# Technical Service Information

## THM 4L60 (700-R4) PREMATURE INPUT CLUTCH FAILURE

Figure 1

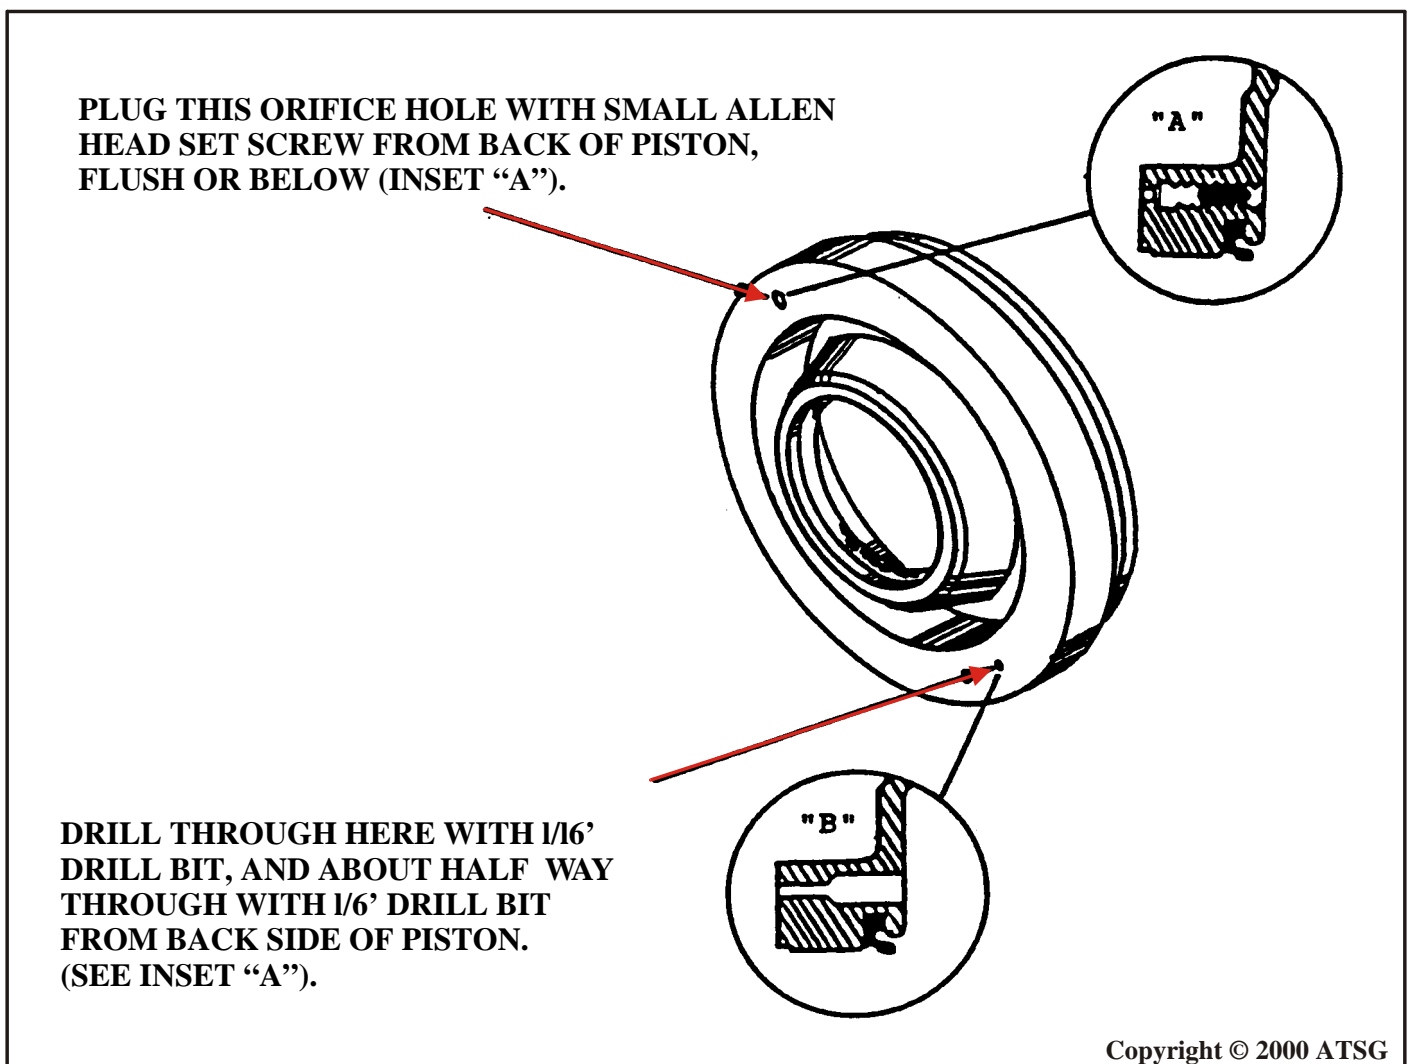
**COMPLAINT:** Premature reverse input clutch failure on 1987 or 1988 models only.

**CAUSE:** The cause may be the orifice hole in the new aluminum piston, drilled too large (Original was .116").

**CORRECTION** Plug the original hole from the back side of piston with an allen head set screw, flush or below. Retain the set screw with Lot-tite (See Figure 1, Inset "A").

180 degrees from original orifice hole you will find a hole started but not drilled through. Drill through here with a 1/16" drill bit, from the front side of the piston. Turn the piston over and from the back side of piston, drill about half way through with a 1/8" drill bit (See Figure1 Inset "B").
